# **Evaluation of Ontario Power Generation Inc. and DNNP LP's Proposed Nuclear Payment Amounts Framework**

Docket EB-2025-0297

May 26, 2026

**Christensen Associates Energy Consulting, LLC**

**Figure 2.1: Impact of CANDU Technology Adjustment on DNGS’s Cost Performance**

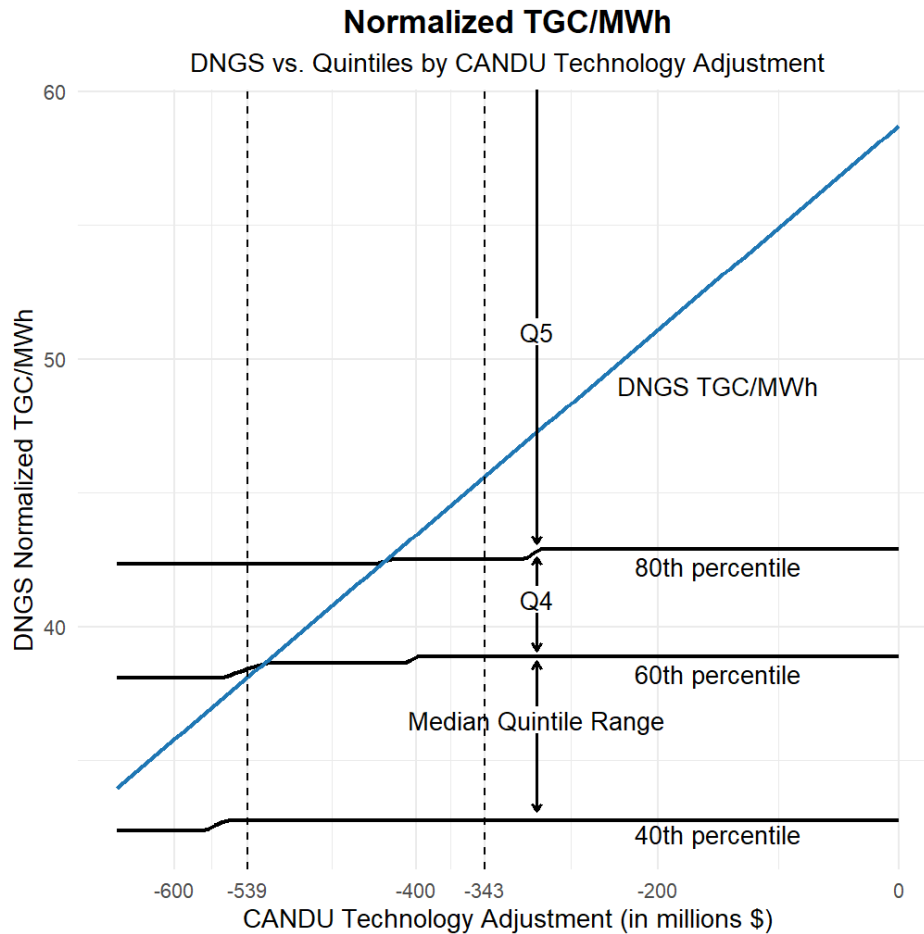
To illustrate the impact of an alternative CANDU technology coefficient on the stretch factor, we recalculate DNGS’s relative normalized TGC/MWh metric as depicted in Chart 16 of Exhibit A1 for different values of the coefficient. The results of this analysis are shown in Figure 2.1.

The blue line shows DNGS’s TGC/MWh for different values of the CANDU coefficient. Note that the adjustment is shown as a negative number since TGC is reduced by the adjustment. Two values of this coefficient are marked by vertical bars. The first is the estimated adjustment of \$539 million from the current ScottMadden study. The second is the adjustment of \$343 million from ScottMadden’s prior study. The black horizontal curves depict the third, fourth, and fifth quintiles, with the third quintile being equivalent to the median quintile range. At the coefficient of \$539 million, DNGS’s normalized TGC/MWh falls just below the 60<sup>th</sup> percentile, and is thus within the median quintile range. This is the result as shown in Chart 16 of Exhibit A1. However, at the coefficient of \$343 million, DNGS’s TGC/MWh is far above the 80<sup>th</sup> percentile, placing it in the fifth quintile.

OPG states “As shown in Chart 16 below, ScottMadden’s econometric analysis concludes that the TGC/MWh of Darlington over the 2021-2023 historic period was \$39.58, once the impacts of the DRP and planned outages are accounted for. This performance puts the station in the median or third quintile of the Electric Utility Cost Group (“EUCG”) peer group. Accordingly, OPG proposes a nuclear stretch factor of 0.3% based on the range of stretch factors set out by the OEB in the RRF.”<sup>19</sup>

**Figure 2.2: Stretch Factor Sensitivity to CANDU Technology Adjustment**

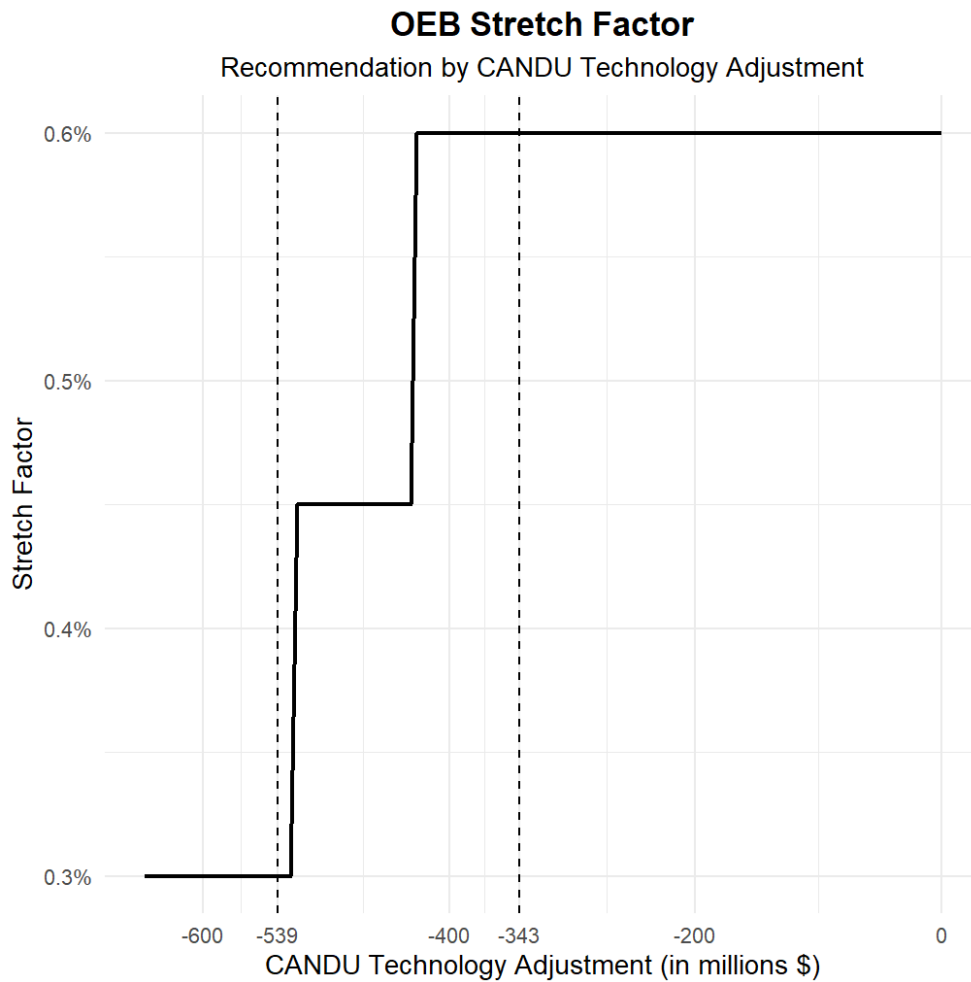
The referenced range of stretch factors set out by the OEB in the RRF implies a stretch factor of 0.45% for plants within the fourth quintile and 0.6% for plants within the fifth quintile. Figure 2.2 shows that if the CANDU coefficient is even slightly overstated and the true coefficient is between \$426 million and \$523 million, a stretch factor of 0.45% would be recommended. If the coefficient is lower than \$426 million as it was in the 2018 study, a stretch factor of 0.6% would be recommended.

This analysis demonstrates that DNGS's measured performance and the corresponding stretch factor are highly sensitive to the CANDU technology coefficient and, given the flaws in the CANDU technology coefficient identified above, suggests that a higher stretch factor should be imposed.

As shown in Figure 2.2, even a slight reduction in the CANDU coefficient from \$539 million to \$523 million would result in a stretch factor recommendation of 0.45.<sup>21</sup> At the very least, given that the CANDU coefficient is inappropriately reducing TGC at Darlington to account for costs at the Bruce plant resulting from the Life-Extension Program, a corrected coefficient lower than \$523 million is reasonable. Given the other flaws with the econometric model discussed above that likely overstate the TGC normalization applied to DNGS, we recommend a stretch factor increase from 0.3 to 0.45. While we have highlighted our concerns with the nuclear outages adjustment, we do not find that it has a material impact on the stretch factor recommendation. This increase in the recommended stretch factor from 0.3 to 0.45 does not incorporate considerations regarding how the stretch factor is applied, which is discussed below in Section 3.
